INDIAN POINT NO. 2 - REACTOR VESSEL EMBRITTLEMENT

This memorandum reviews the "First Supplement to Preliminary Safety Analysis Report" (Ref. 1) for the Consolidated Edison's Indian Point Unit No. 2, with reference to maximum fast neutron exposure of the pressure vessel and the corresponding shift in the NDT temperature. According to my calculations, the reported time-integrated fast (>1Mev) neutron exposure of the vessel of $0.85 \times 10^{19} n/cm^2$ seems realistic, considering core size, power density and the inner diameter of the reactor vessel. Attached to this memorandum is a copy of Westinghouse reference design curves for the prediction of NDT temperature shift, a list of references for the data points, and a fracture analysis diagram used by the applicant to estimate the embrittlement safety margin.

FRACTURE ANALYSIS DIAGRAM

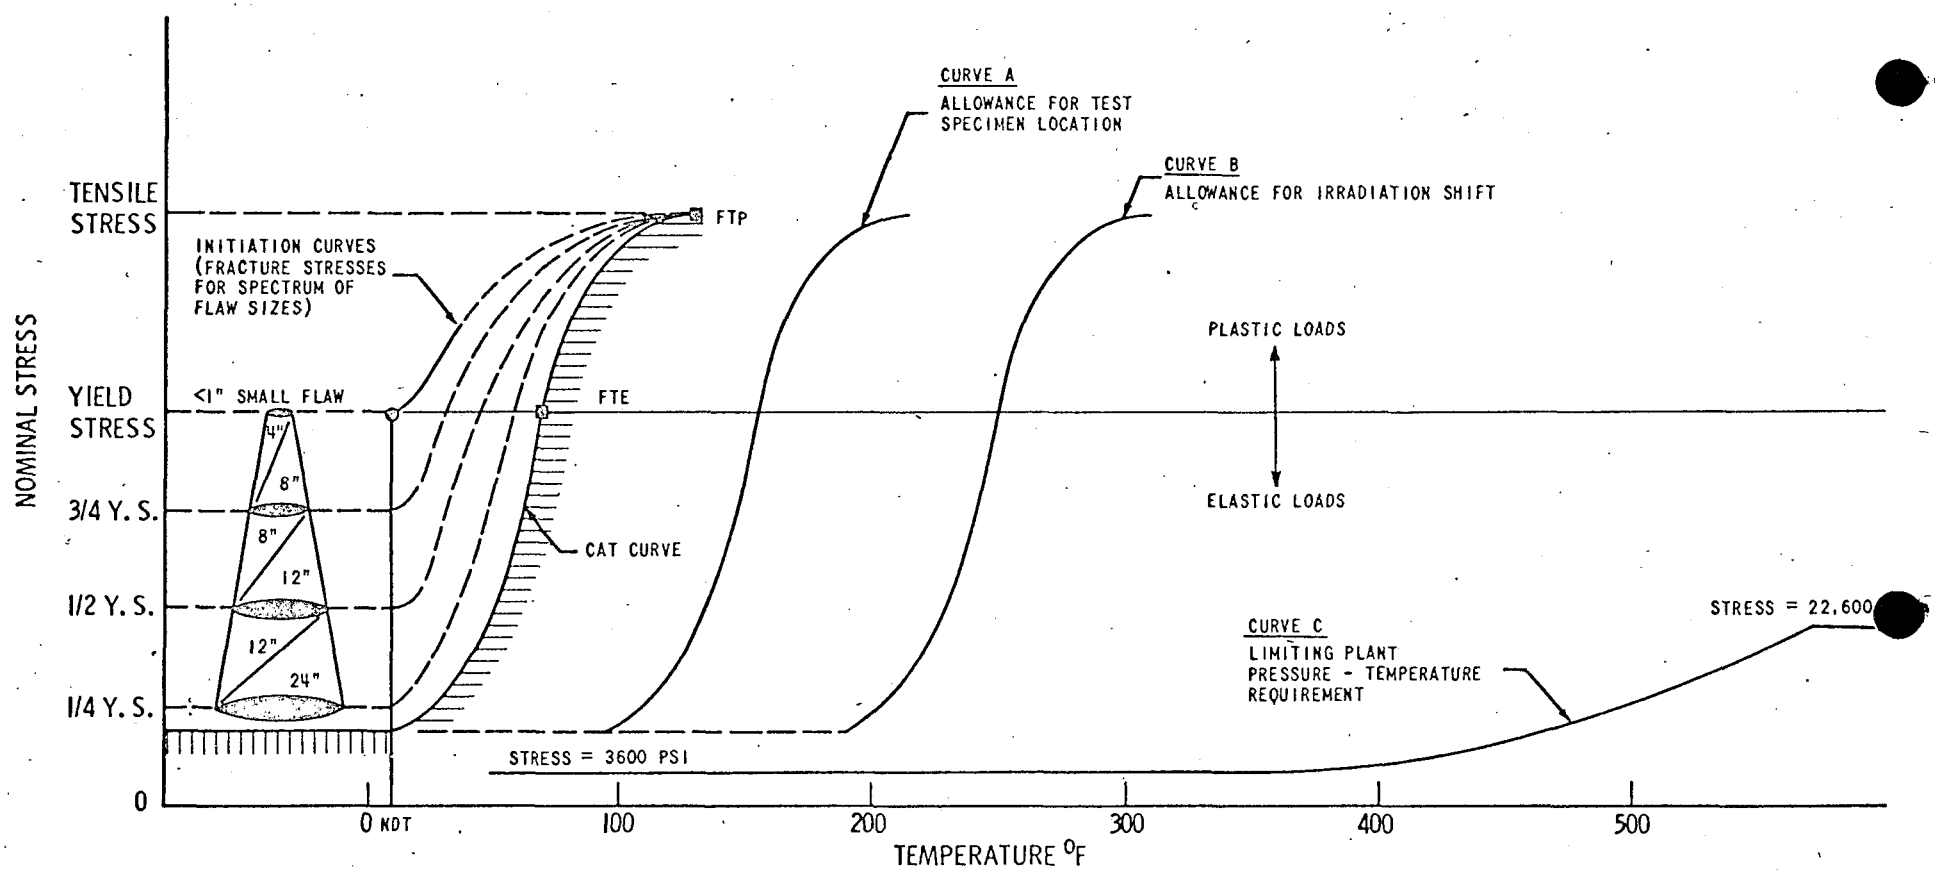
The shift in the NDT temperature at the inner surface of the vessel wall, due to fast neutron exposure, was estimated as 160°F using the 550°F curve (attached). To account for the variation of NDT temperature across plate thickness, the applicant assumed (most likely based on Yankee measurements) that the initial NDT temperature at plate center may be up to 85°F higher than that at quarter thickness. However, while the impact properties are lowest at plate center, the transition temperature shift there was calculated to be only 85°F. Curve A in the attached Fracture Analysis Diagram represents the initial NDT temperature at plate center, and curve B the corresponding shift of 85°F.

The fracture analysis diagram, used by the applicant to estimate his safety margin with respect to neutron embrittlement of the reactor vessel, was obtained from the NRL Report 5920 (Ref. 2). Using this diagram, and assuming a total NDT shift of 170°F (85° due to reduced impact properties at plate center and 85°F due to irradiation), the applicant found a margin of well over 200°F between limiting plant operating conditions (Curve C) and the nearest point on the Crack Arrest Curve, adjusted for the NDT temperature shift (Curve B). It seems significant that the available safety margin was estimated using the CAT curve, rather than the 20% yield stress point at the (NDT + 60) temperature.
